May 16, 2013

TO: Dominic Yballe
FROM: Steve Morrow
SUBJECT: NWP-2008-414 – Proposed Project Amendment

LRT(NPH) PLAN AND ELEVATION

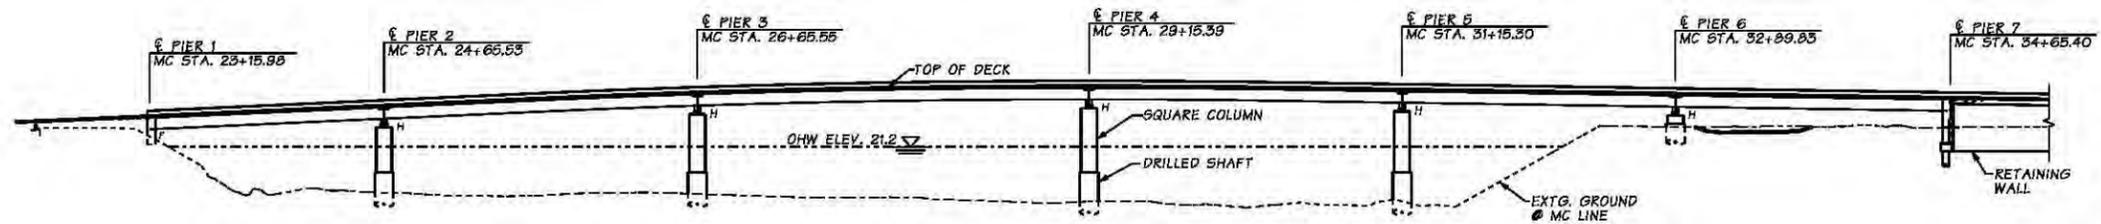
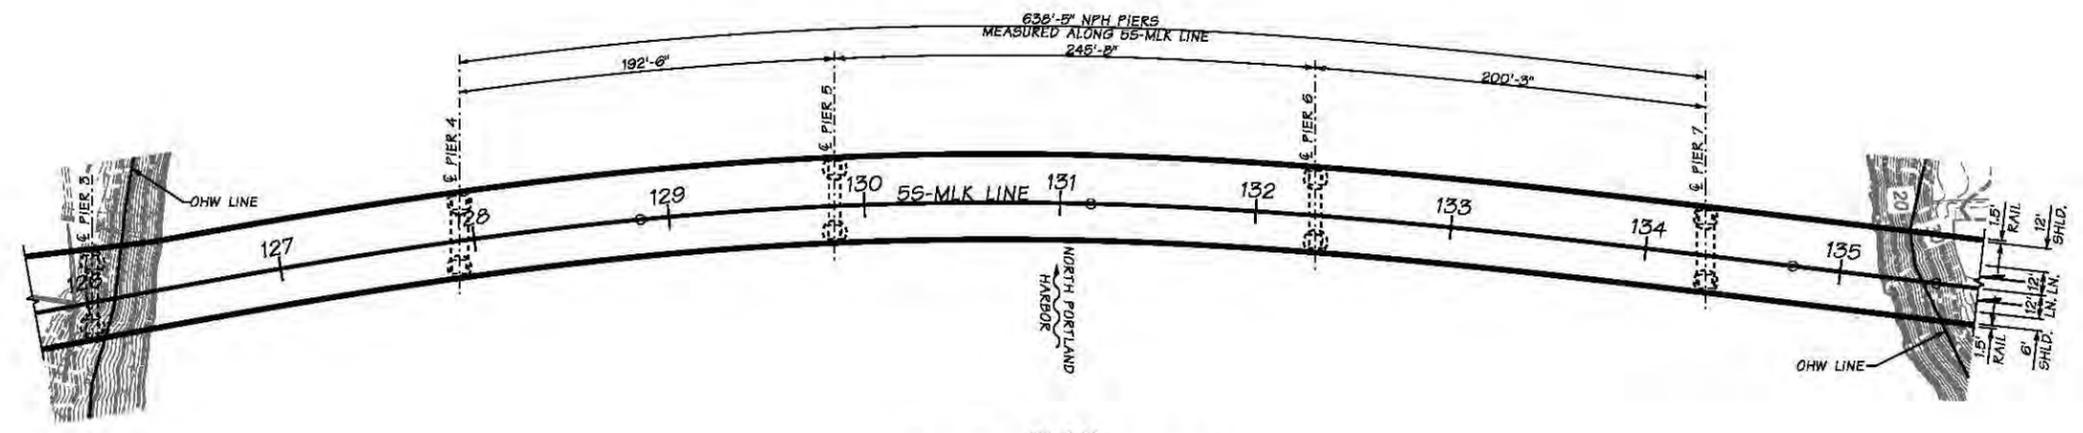
- The construction of each column will require the installation of an over-sized casing (small diameter cofferdam).

The current designs for the bridges across the North Portland Harbor include lowering of the shaft-to column transition to approximately the mudline and maintaining the single shaft-to single-column approach. The construction of the column-to-drilled shaft transition would require isolating the work area in the water to allow the work to be performed in the dry. This

construction method will be implemented by installing either an oversized circular casing or a circular cofferdam. Tables 1, 2, and 3 below summarize the dimensions and timing of these cofferdams, the approximate area for each cofferdam, and the total areas anticipated for all the cofferdams in the North Portland Harbor. Casings/cofferdams will be seated into the sediment with a vibratory driver. Fish salvage would occur during and after isolation. The first six feet of sediment will be removed to provide a stable foundation for a concrete seal, and the drilled shaft casing will be installed. The top of the drilled shaft casing will extend above the top of casing/cofferdam to allow construction of the drilled shaft prior to dewatering. The drilled shaft will be constructed within the drilled shaft casing, and the excavated material from the drilling will be removed. Removed sediments will be disposed of in accordance with relevant permits. As presented in the Oregon JPA, a reinforcement cage and concrete will be placed within the drilled shaft casing up to the shaft/column transition zone. A concrete seal will be poured in the annular space around the drilled shaft casing within each casing/cofferdam at the mudline to prevent water from entering the cofferdam through hydraulic pressure. The top of the seal will be at or within one foot of the existing mudline, resulting in a concrete seal that is six feet in depth. Rebar or other reinforcing structure will likely not be needed in the seal concrete. Water from within the casing/cofferdam will be pumped to a holding tank and disposed of in accordance with permit requirements to provide a dry work area. Once the casing/cofferdam is pumped dry, the drilled shaft casing will be cut off at the elevation of the bottom of the column (approximately the top of the seal), and the column of the bridge will be constructed. As many as 16 of the 36 total over-sized casings/cofferdams will be in place at any one time.
